**BUILDINGS 5 & 6 RENOVATIONS**

**BID ADDENDA**

MECHANICAL  
DUCTWORK PLAN  
THIRD FLOOR

Date 08/29/08  
Scale AS NOTED  
Project Number 07013  
Drawing Number **M2.3d**

**1 MECHANICAL DUCTWORK PLAN - THIRD FLOOR**  
SCALE: 1/8"=1'-0"

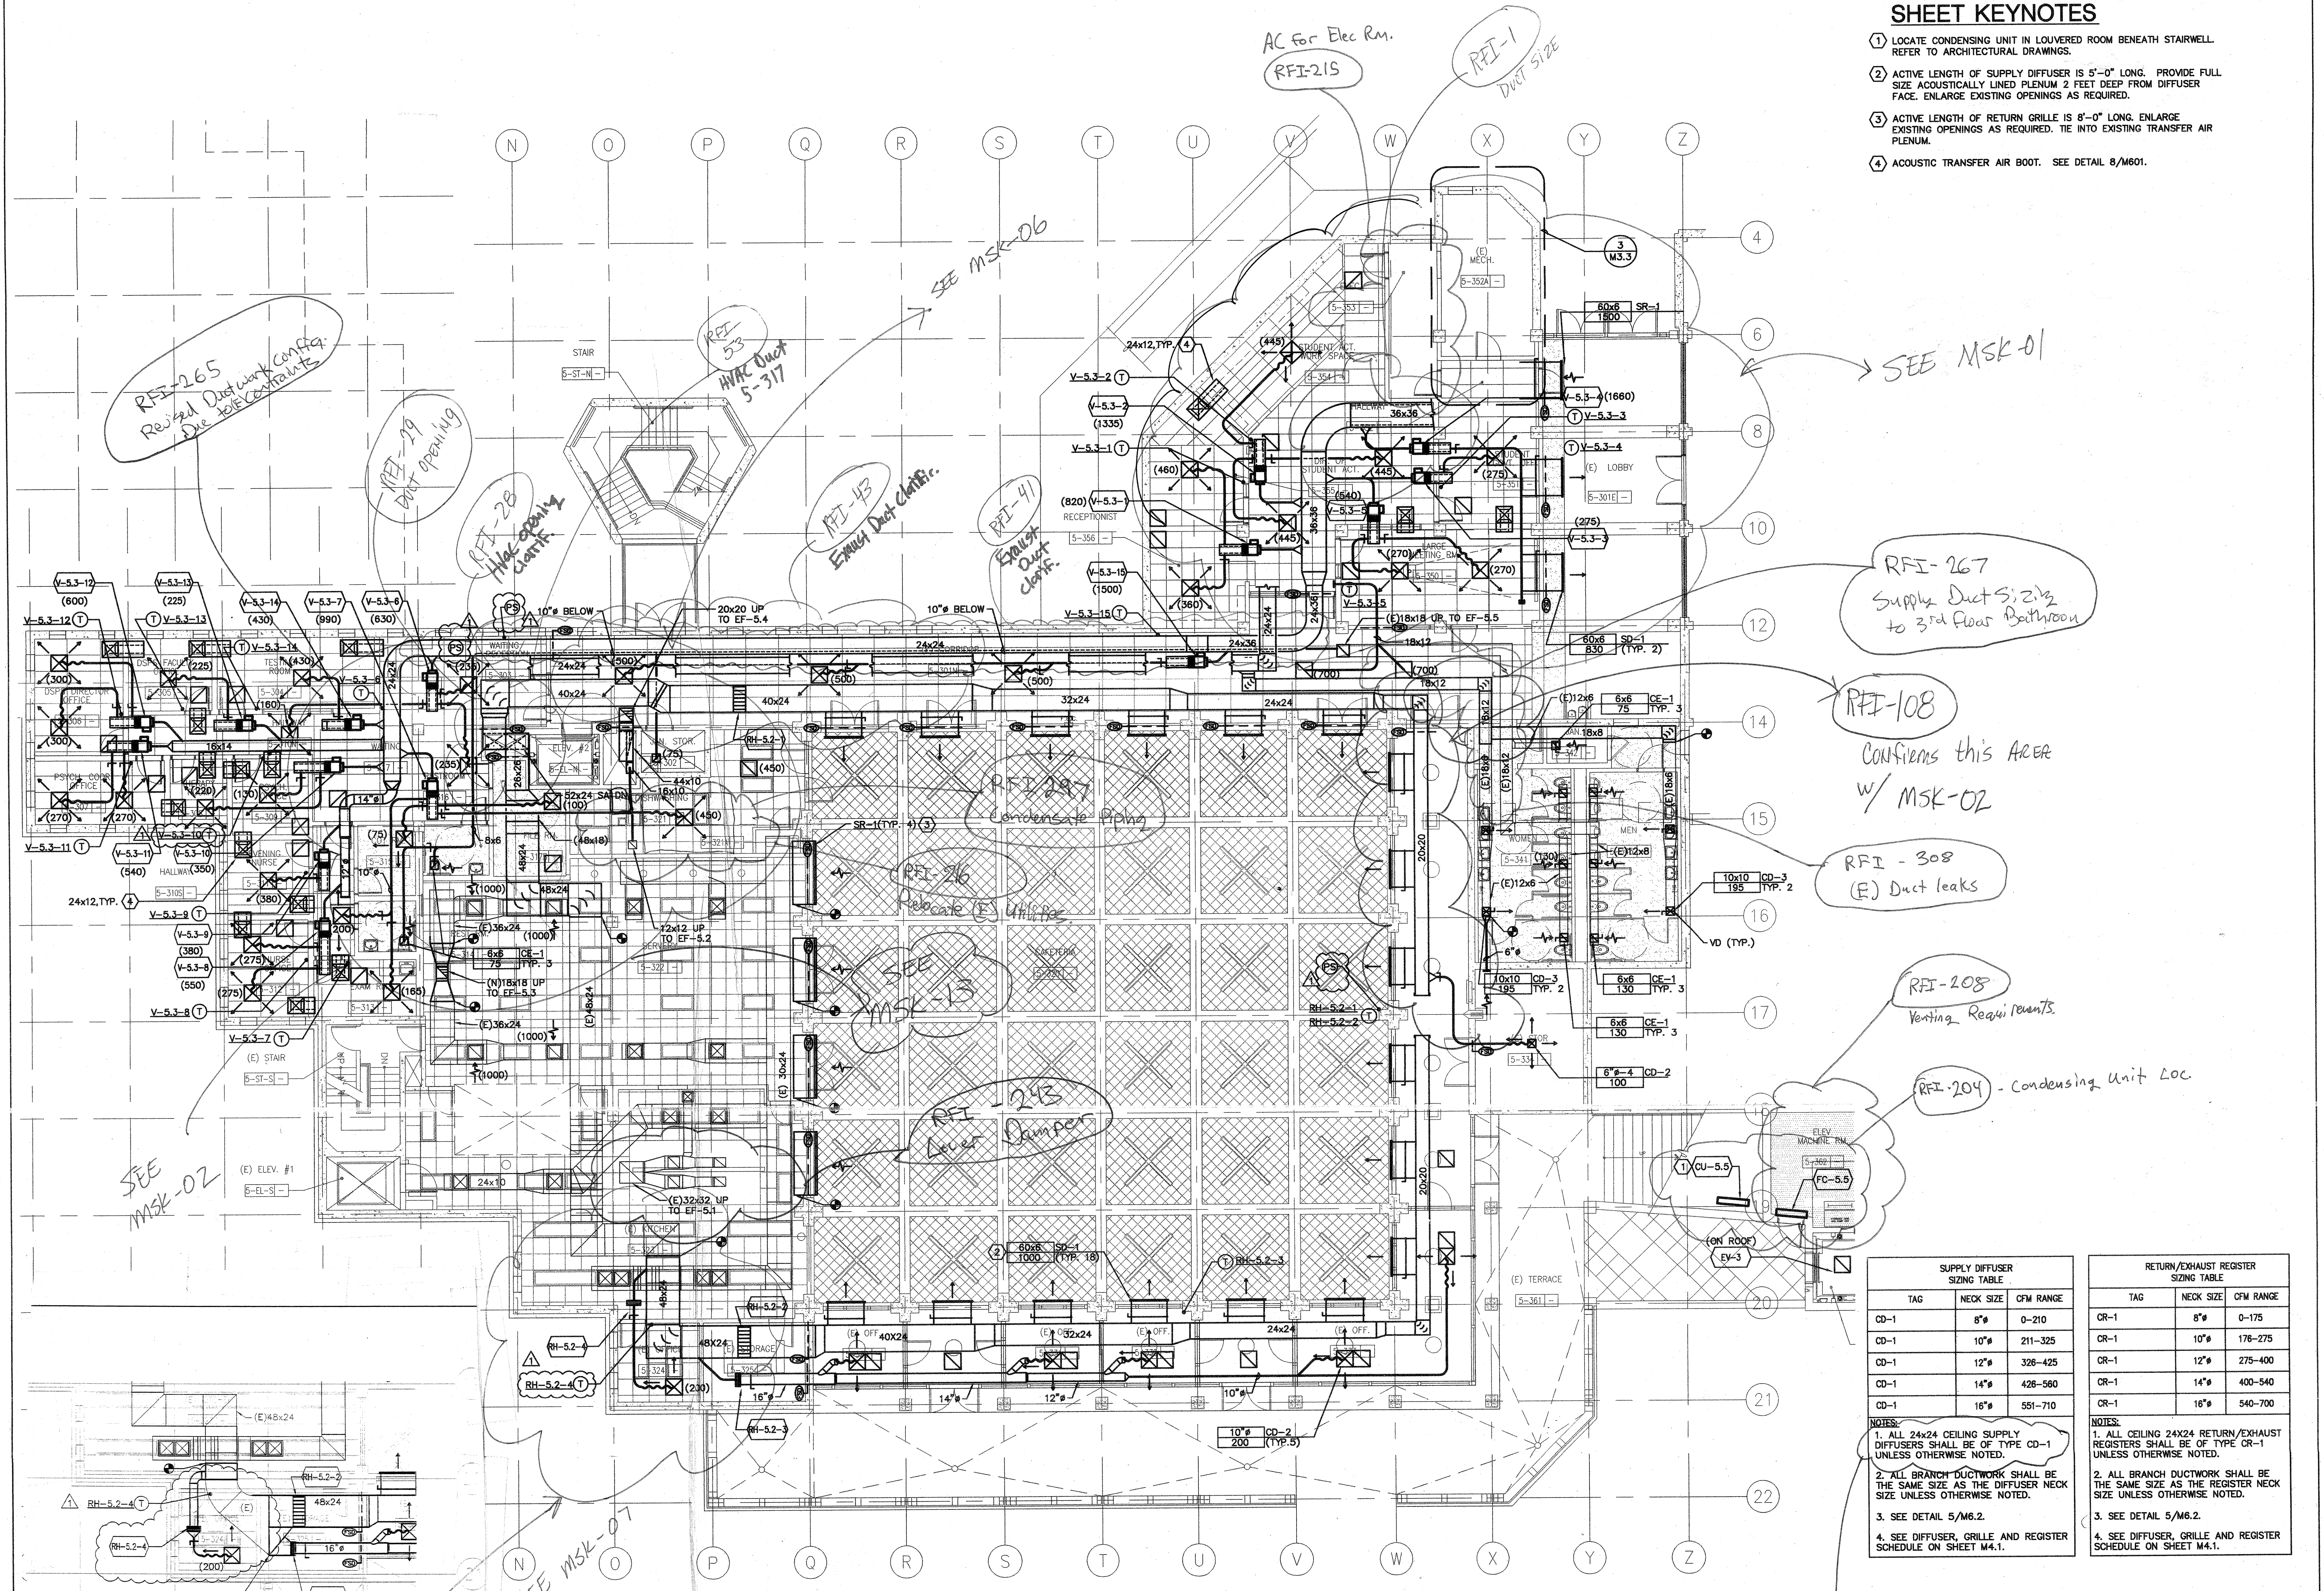
- LOCATE CONDENSING UNIT IN LOUVERED ROOM BENEATH STAIRWELL. REFER TO ARCHITECTURAL DRAWINGS.
- ACTIVE LENGTH OF SUPPLY DIFFUSER IS 5'-0" LONG. PROVIDE FULL SIZE ACOUSTICALLY LINED PLENUM 2 FEET DEEP FROM DIFFUSER FACE. ENLARGE EXISTING OPENINGS AS REQUIRED.
- ACTIVE LENGTH OF RETURN GRILLE IS 8'-0" LONG. ENLARGE EXISTING OPENINGS AS REQUIRED. TIE INTO EXISTING TRANSFER AIR PLENUM.
- ACOUSTIC TRANSFER AIR BOOT. SEE DETAIL 8/M601.
